Meadowbank 2024 Annual Open Pit Geomechanical Inspection

**RE: Meadowbank Complex - Meadowbank Site - 2024 Annual Open Pit
Geomechanical Inspection**

Meadowbank Complex - Meadowbank Site - 2024 Annual Open Pit Geomechanical Inspection

Looking East at Settlement and Scarps on the Dump Platform

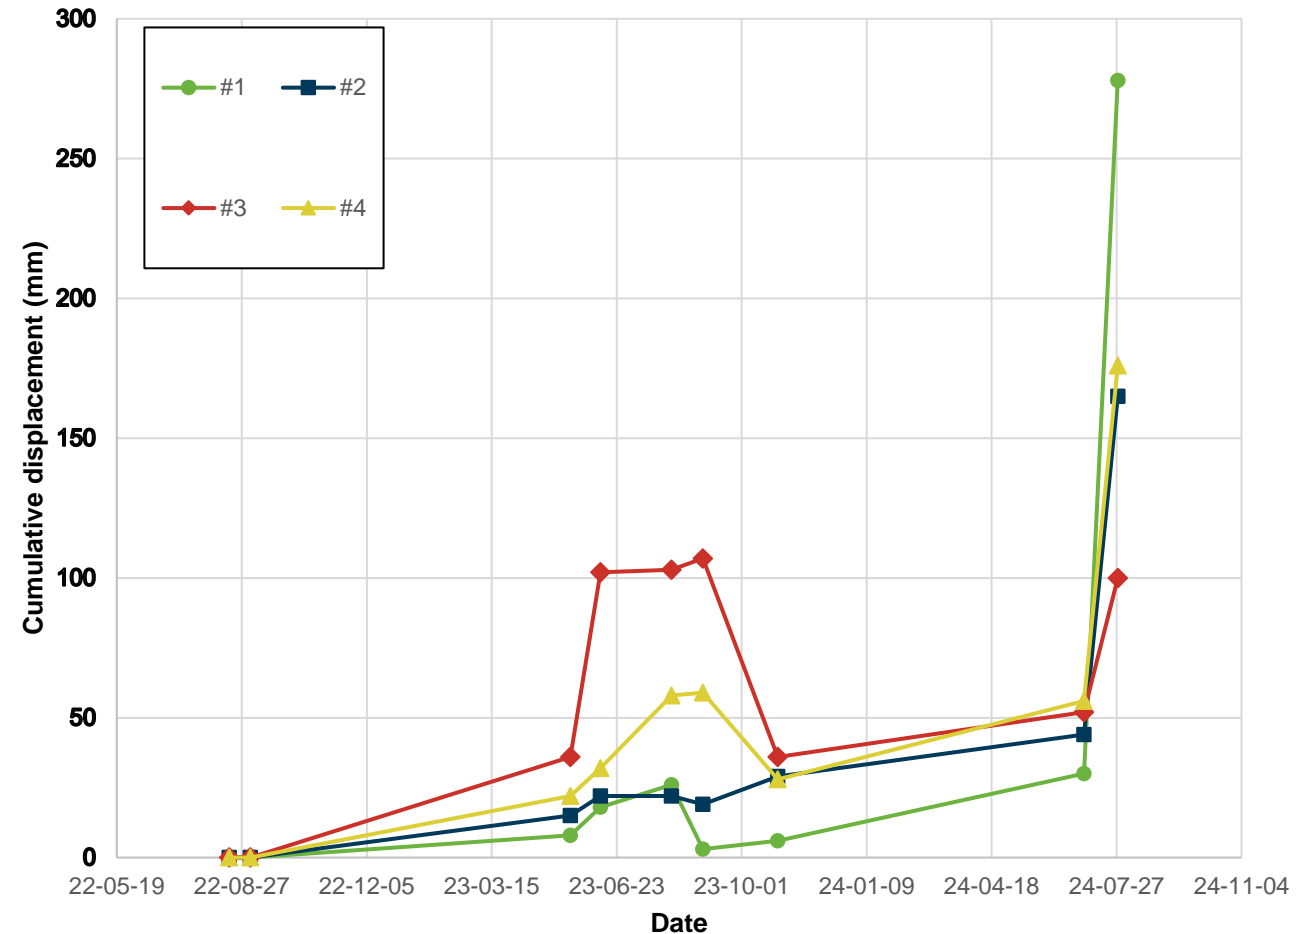
- The dump is inactive, and access is prevented by both a rockfill berm and the presence of water pipes across the access point.
- The dump has been subsiding since 2015. The settlement is attributed to the deposition of water in the open pit, through a combination of thawing and increasing porewater pressure. The concern is that a sudden failure of the dump could create a wave that poses a hazard to personnel conducting water quality or tailings sampling in the pit lake.

- The settlement has resulted in a series of scarps along the dump platform, that are now 2 to 3 metres in height (see photo below).
- The settlement is monitored as part of monthly inspections by the Geotechnical Group visually and using four survey pins installed in 2022. The observed deformation is discussed further on the following slide.

- Personnel are accessing the pit lake more often this summer due to Environmental monitoring and closure-related work. As a result, there is increased exposure of personnel to a dump failure.

B Dump - General

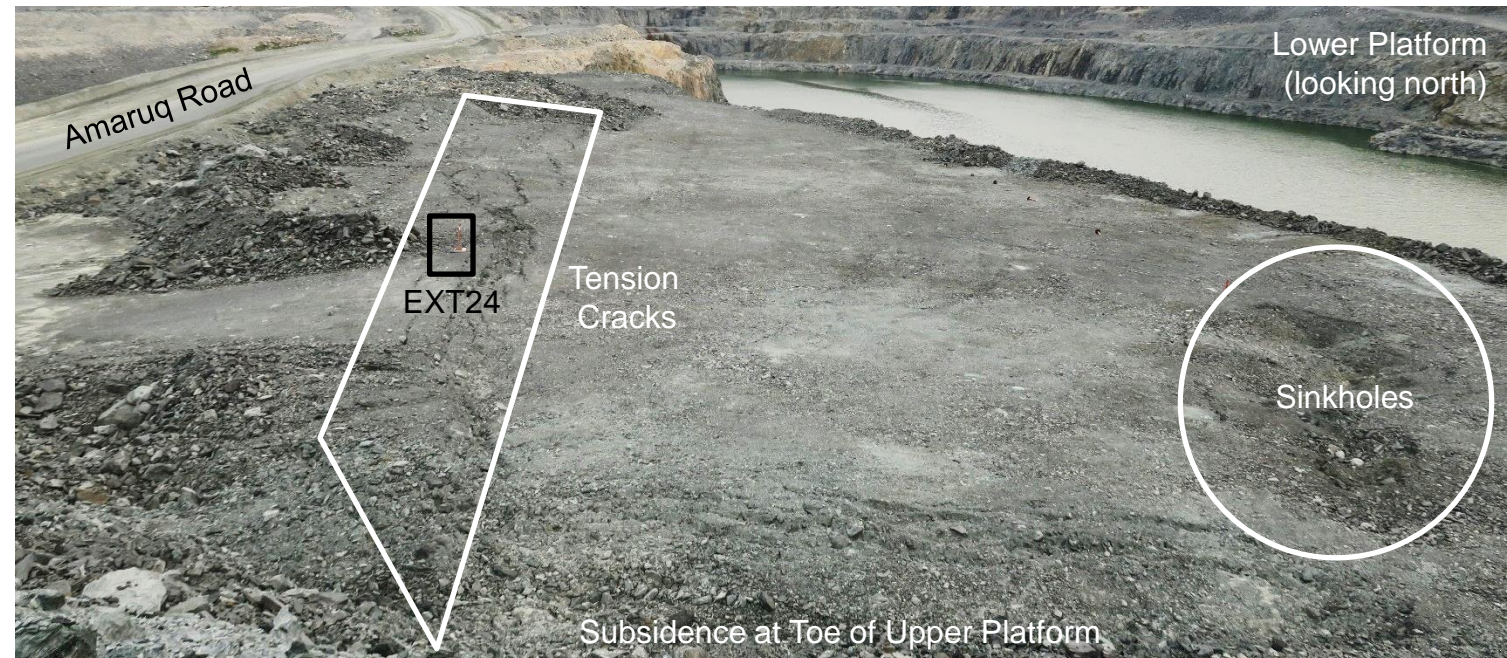
- The B Dump consists of an Upper and Lower Platform, both of which are inactive. Access to both platforms is prevented by berms.
- Failures of the dump slope are possible as the pit lake elevation rises but have not been observed to date. Such a failure could cause a large wave in the pit lake that poses a hazard to personnel conducting water sampling or managing the reclaim water lines.

- Tension cracks and subsidence continue to be observed on both platforms. The northern end of the Lower Platform has experienced the most subsidence. Sinkholes have also formed at the southern end of the Lower Platform. These are discussed on the following slides.

- An extensometer has been installed on the Lower Platform and this is described further on a following slide.
- The possibility of the settlement progressing back to the Amaruq Road was discussed in 2022 and concluded to be unlikely as the settlement and tension cracks appear to be limited to within the footprint of the pit. WSP was retained to complete a detailed assessment. The results are expected later this year and should be reviewed when they become available.

B Dump - Upper Dump Platform

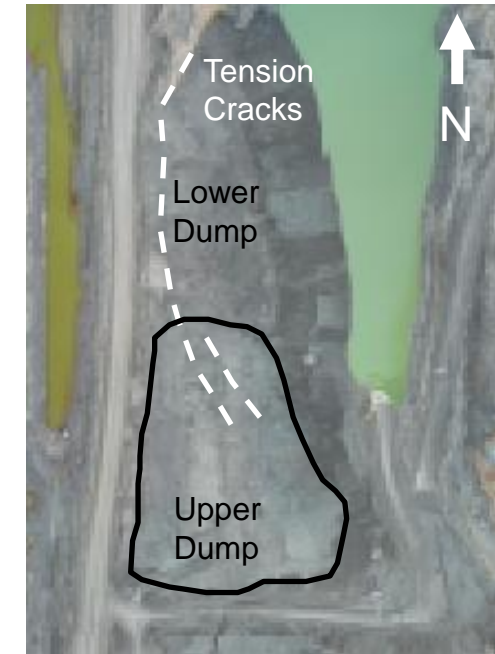
- The NW-SE tension cracks at the northern end of the Upper Platform have continued to develop since the 2023 inspection.
- The orientation of the cracks suggest that they are also linked to the geometry of the underlying pit slope. The position of the cracks should be surveyed and confirmed relative to the pit geometry.

Electrical Junction Box at Crest, Inside Berm (2024)

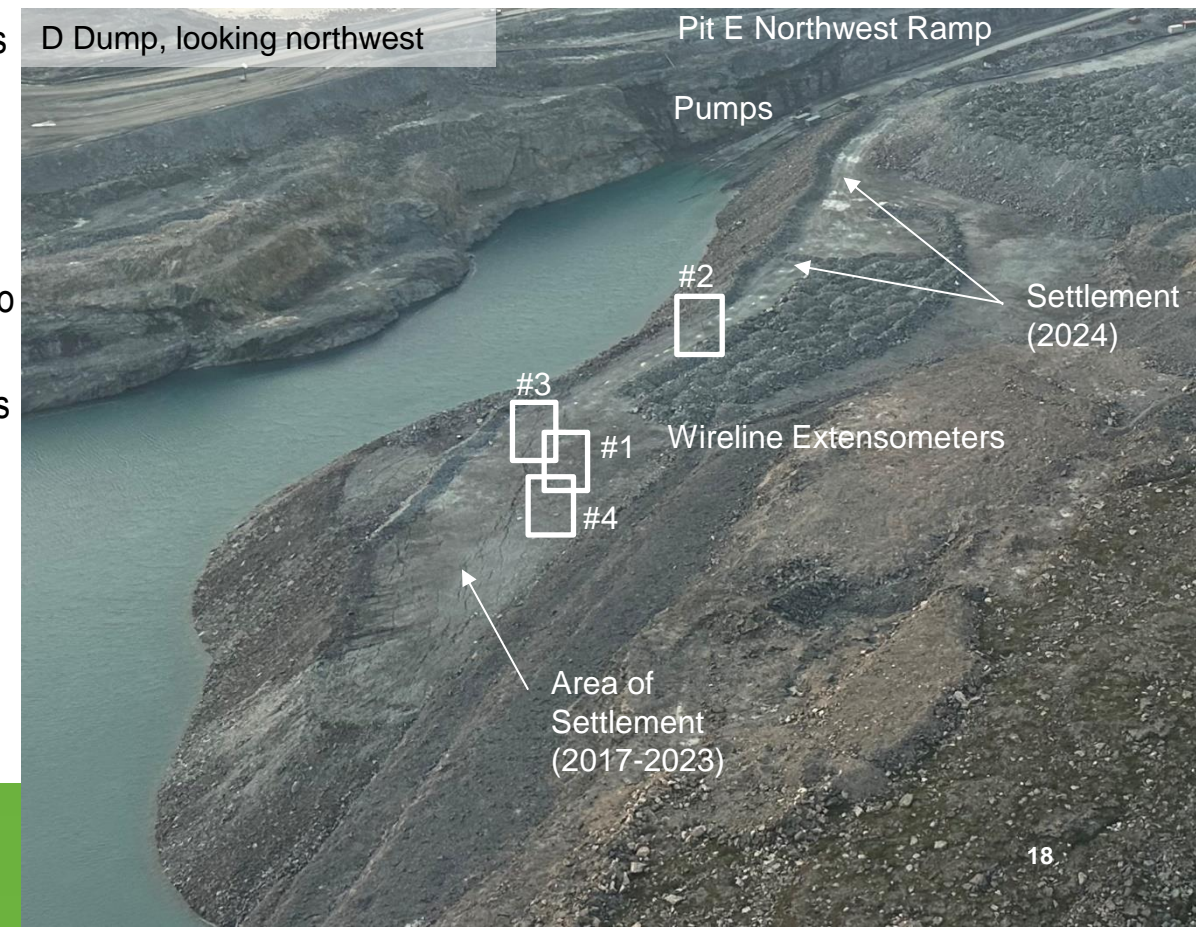
- The ABF Garage was constructed on the C Dump platform in 2020 but was dismantled and moved off of the dump in 2023.
- Several electrical panels for the Pit A pumps were located inside the berm constructed along the crest. Since the 2023 inspection, the panels have been relocated outside of the berm and only a single junction box remains.

- Settlement of the dump is possible as the water elevation in Pit A and the water/tailings elevation in Pit E reach and surpass the base of the dump (approximately 5085 mRL). The current water elevations in Pit A (5103.6 mRL) and Pit E (5102 mRL) have risen above the base of the dump and it is believed that water is now flowing from Pit A to Pit E below the dump. However, no evidence of settlement or instability has been observed to date.

- As no evidence of instability has been observed, and settlement is likely to be gradual, the ongoing use of the dump as a laydown is considered acceptable.

D Dump - Extensometers

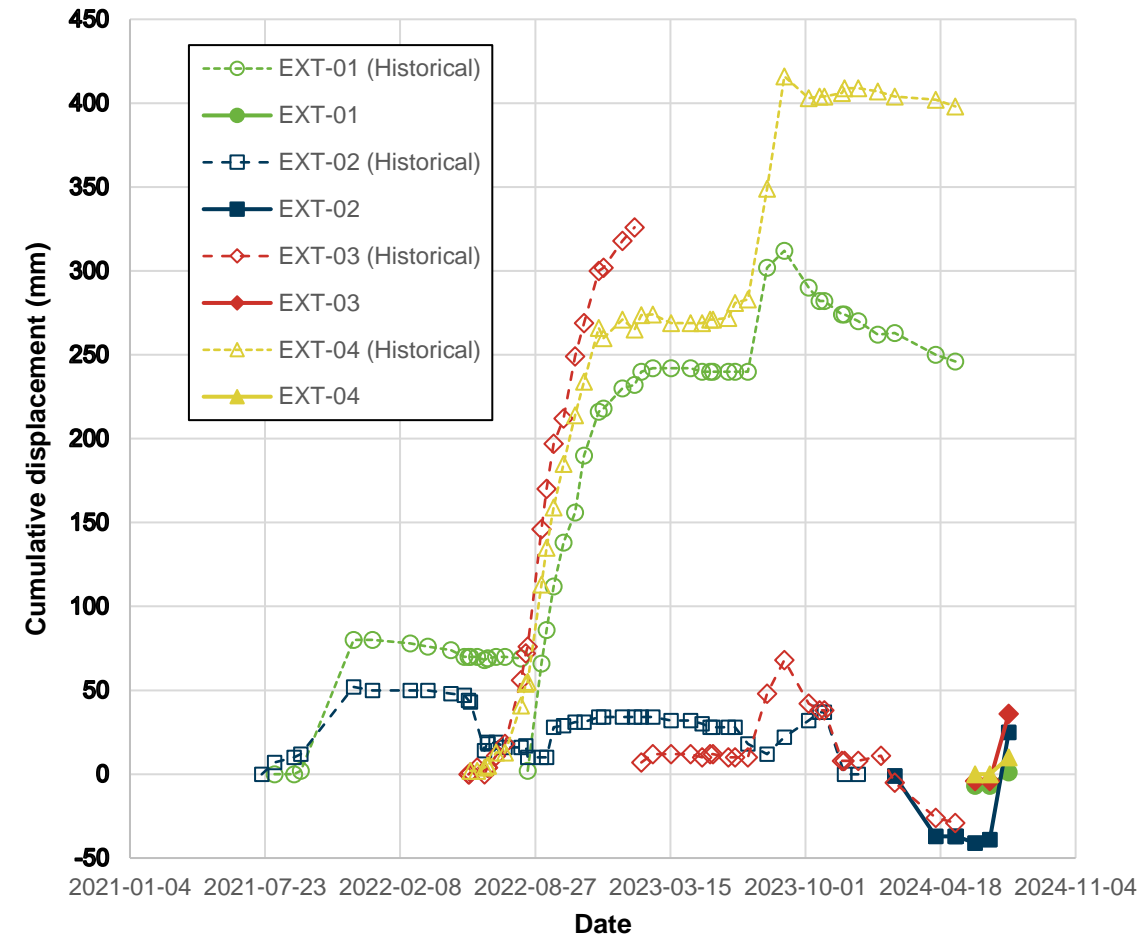
- The Geotechnical Group commit to monitoring the extensometers on a monthly basis.
- As the tensions cracks have progressed behind the extensometers, they have been repeatedly moved, resetting the data. The data are shown at right.

- A potential seasonal trend is observed in the data, with an increase in displacement over the summer months. The displacement rate varies between approximately 3 mm/day to less than 1 mm/day. This is within TARP Blue (Stable) status.

- The spatial extents of the settlement exceed what can be practically monitored with four extensometers and the need to repeatedly move the instruments limits the ability of the mine to assess long term trends. Recommend using drone photogrammetry to better understand the spatial distribution of the deformation. The use of the extensometers could be limited to areas with increased exposure (e.g., above the pumps on the Pit E Northwest Ramp).

Piezometer cable along South Wall Ramp

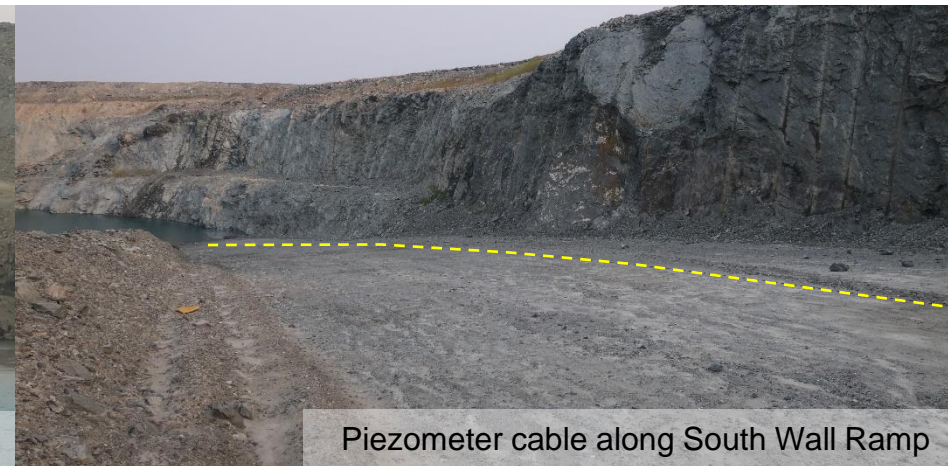
- Approximately one and a half benches are exposed above the pit lake.
- The wall is performing well and no particular geomechanical concerns were noted.
- No significant change in the historical bench-scale instabilities along the south wall were observed.
- The ramp along the south wall was previously closed with a berm. At the time of the annual inspection, the berm had been partially removed and the ramp used to install a vibrating wire piezometer in the pit lake. The berm should be replaced.
- The vibrating wire piezometer cable run along the ramp (in yellow, below right) is located close to the pit wall. Rockfall is present on the ramp in this area. The cable should be relocated away from the pit wall (e.g., to the berm on the outside of the ramp).
- The ramp at the north end of the open pit is described on a following slide.

-	-	-	A vibrating wire piezometer has been installed at the base of the South Ramp. The cable for the piezometer runs along the ramp, within 5 m of the bench face. There are numerous active rockfall hazards along this ramp and a rockfall berm has not been established.	Re-locate the cable for the vibrating wire piezometer away from the wall. Alternatively, establish a rockfall berm along the inside of the ramp.	P3

Pit E - Northwest Wall and Ramp

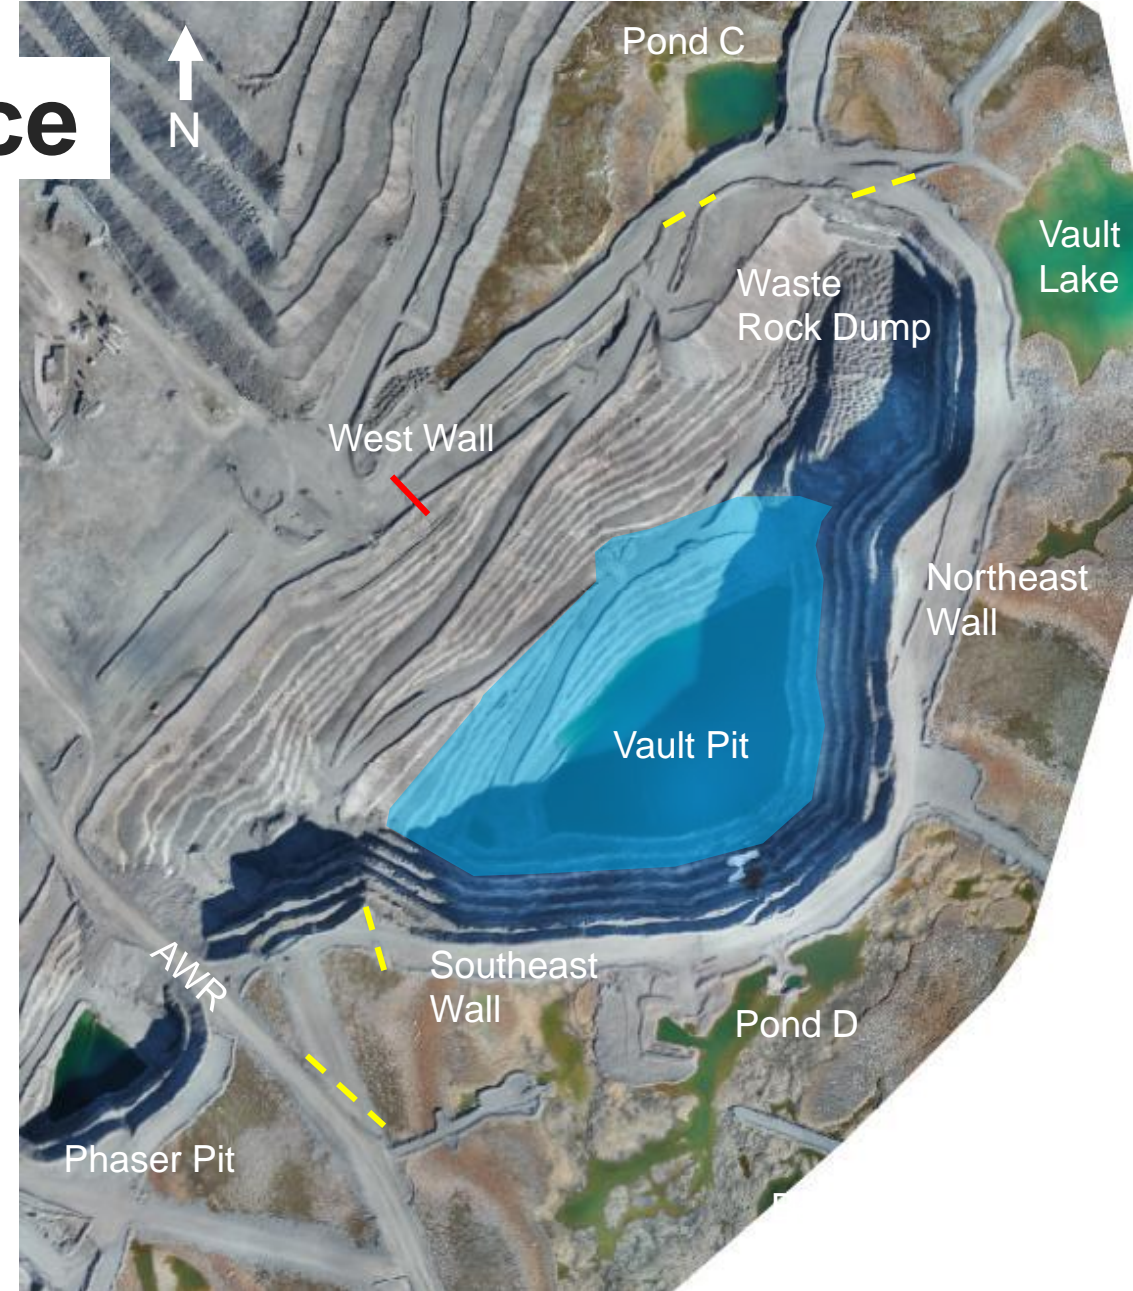
- The Northwest Ramp is used to access the pit lake and water management infrastructure is present along the ramp.
- Multiple rockfall hazards have been previously identified along this wall. With the rise of the pit lake, most of these hazards have been flooded and no longer pose a risk to personnel. However, a rockfall hazard remains on the Northwest Wall adjacent to the pumps, where a fault intersects the wall.
- The rockfall berm at the toe of the pit slope has been effective at managing rockfall. Over the last year, the berm was locally repositioned closer to the slope to create room for the pumps. The reconstructed berm is relatively short and may not be an effective rockfall barrier. Recommend increasing the height of the berm in this area to match the remainder of the berm.

Southwest Wall, looking southwest

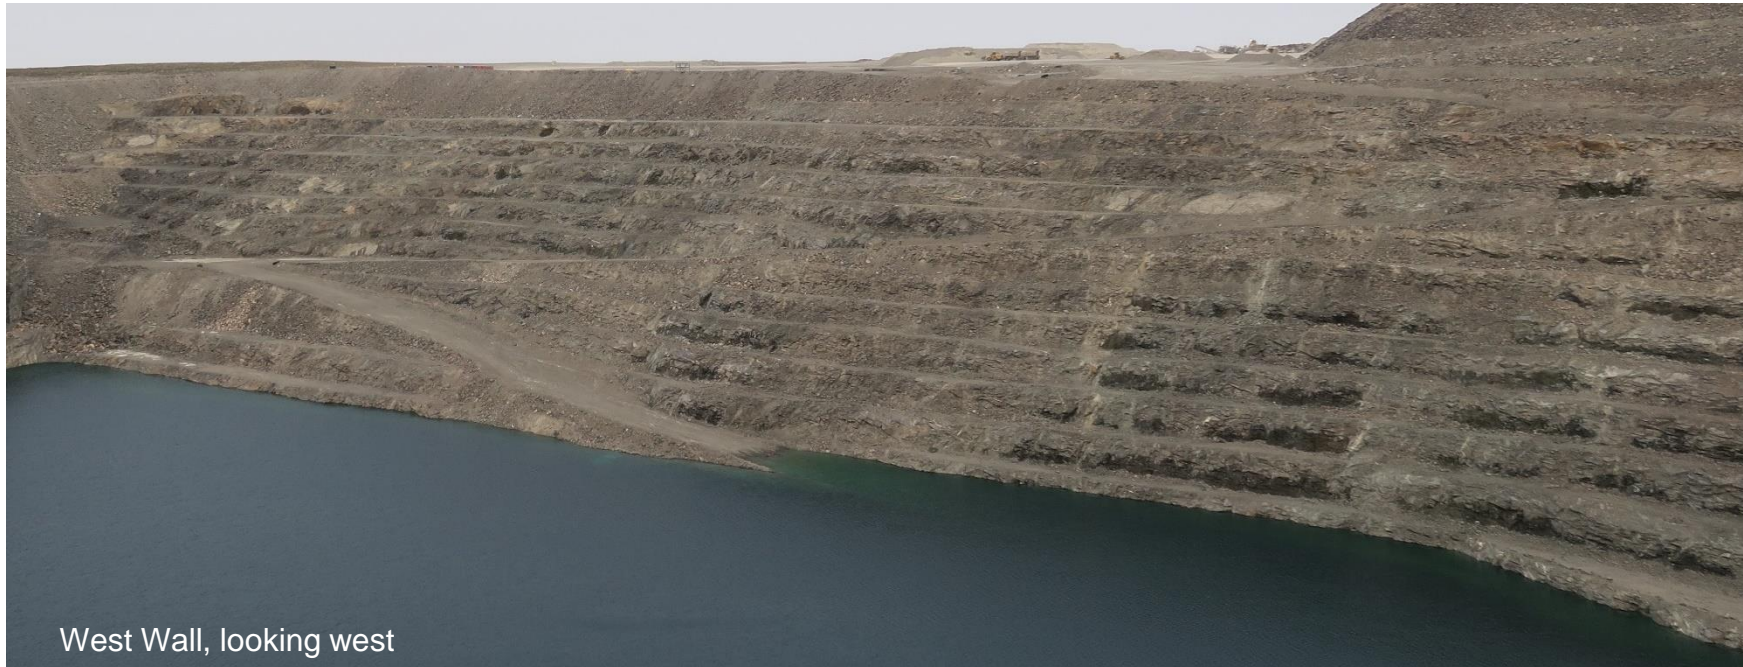
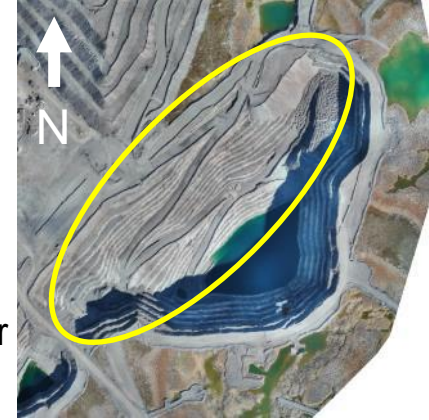
- The Amaruq AWR crosses a saddle between the Vault and Phaser pits on a rockfill embankment.
- During the winter of 2023, tension cracks were observed on the surface of the road, perpendicular to the axis of the road. The cracks have not been observed since and may have been due to frost heave within the upper road surface.
- No evidence of instability in the AWR embankment was observed during the inspection (e.g., no tension cracks on the road surface or bulging of the embankment toe).
- The stability of the Amaruq AWR embankment could be impacted if the water level in the Phaser Pit on the other side of the embankment increases and water ponds behind the embankment. This has not occurred. No seepage was observed at the time of the inspection. The presence of seepage should continue to be evaluated as part of the monthly inspections. Recommend noting the importance of this in the GCMP.

Looking west at Area of Settlement

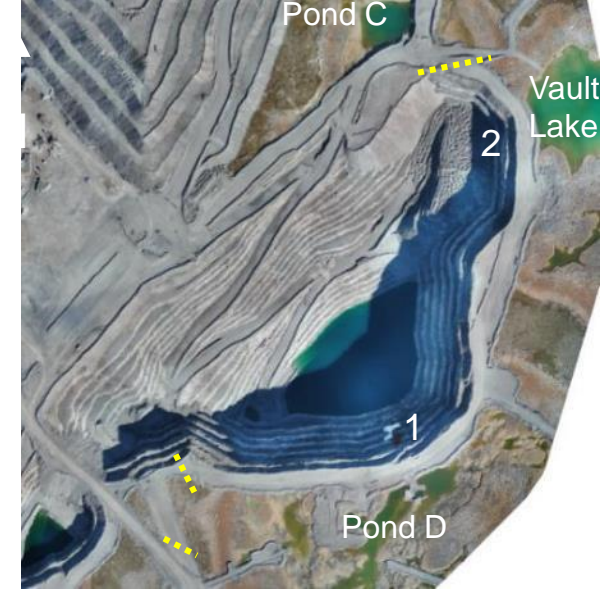
- A waste rock dump was constructed at the north end of the Vault Pit. The dump is inactive and consists of two platforms with elevations at approximately 5133 mRL and 5082 mRL.
- Settlement and tension cracks were observed at the crest of the upper platform at the north end of dump during the 2019 inspection. There appears to have been little change since that time. The affected area is relatively small and is not above the ramp.
- No other evidence of instability was observed during the inspection.
- Access to the dump is prevented with a berm.
